MEMORANDUM

TO: District of Columbia Zoning Commission

DATE: July 31, 2017

SUBJECT: Large Tract 2017-02 – Bryant Street (Square 3629, Lot 7, 813, 814)

Figure 3 – Proposed Loading and Parking Access Locations (Source: CTR, April 6, 2017, Gorove/Slade, Figure 16)

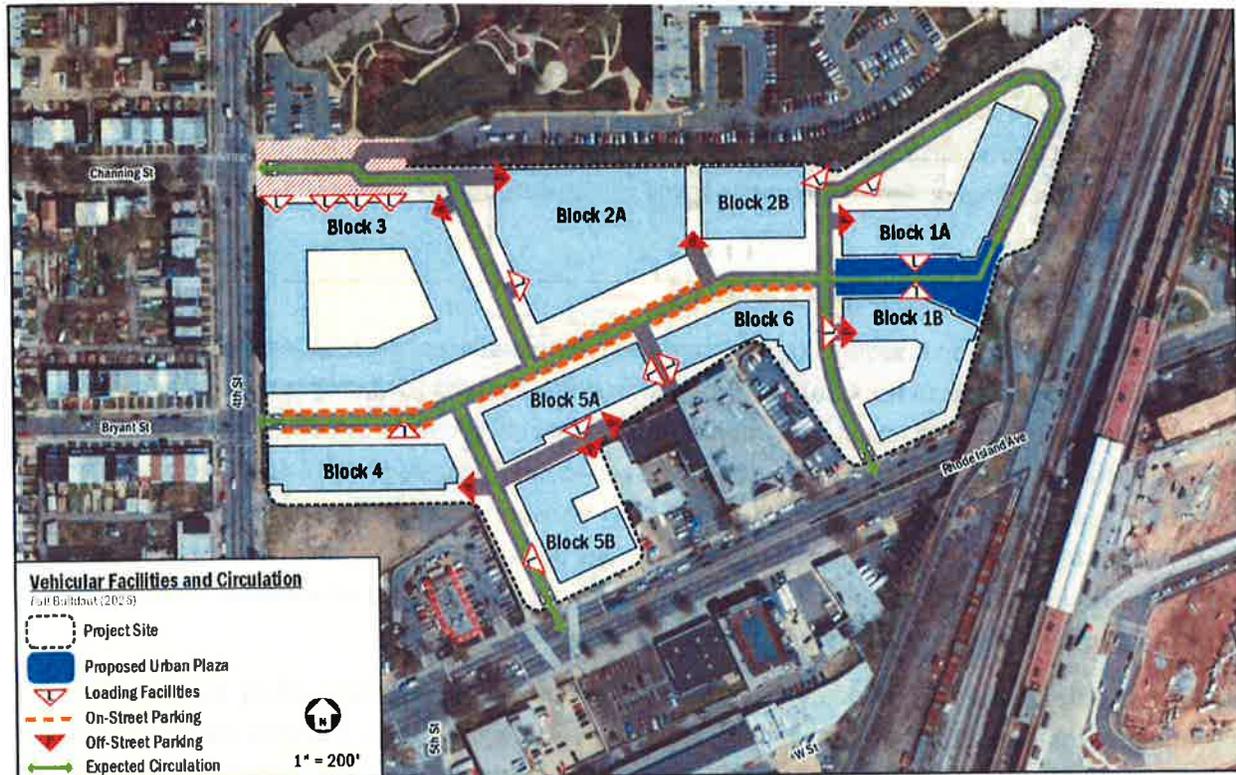
In terms of loading locations, DDOT finds the loading entrances are located appropriately since these are on private streets and no backing maneuvers are anticipated in public space. DDOT does not support backing movements for loading within public space. While the proposed loading is located off of private streets, DDOT would assert that the backing maneuvers may not represent safest practice. Loading locations are shown on Figure 3.

Figure 6 – Pedestrian Network (Source: CTR, April 6, 2017, Gorove/Slade, Figure 47)

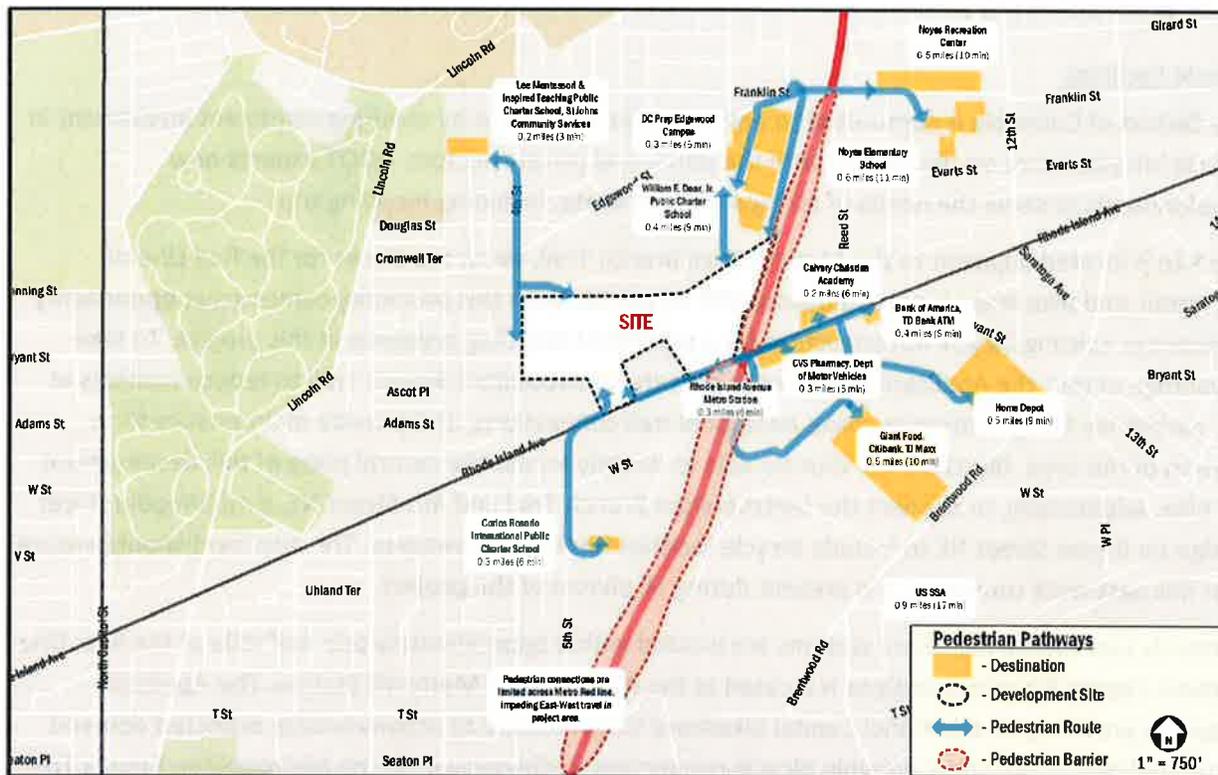
The proposed Site design includes many opportunities to promote walking. New sidewalks that accompany the Site’s street network as well as additional pedestrian connections provided offer excellent pedestrian facilities internal to the Site. The Applicant also performed an inventory of the pedestrian infrastructure in the vicinity and noted any substandard conditions. Improvement to pedestrian routes towards key destinations is pertinent to this project. Potential pedestrian pathways are shown in Figure 6.

As discussed in the Site Access section, the Applicant is expected to work with DDOT through the public space permitting process and/or street dedication process to ensure that pedestrian access points provide safe and convenient Site access, with a focus on connecting to adjacent neighborhoods and
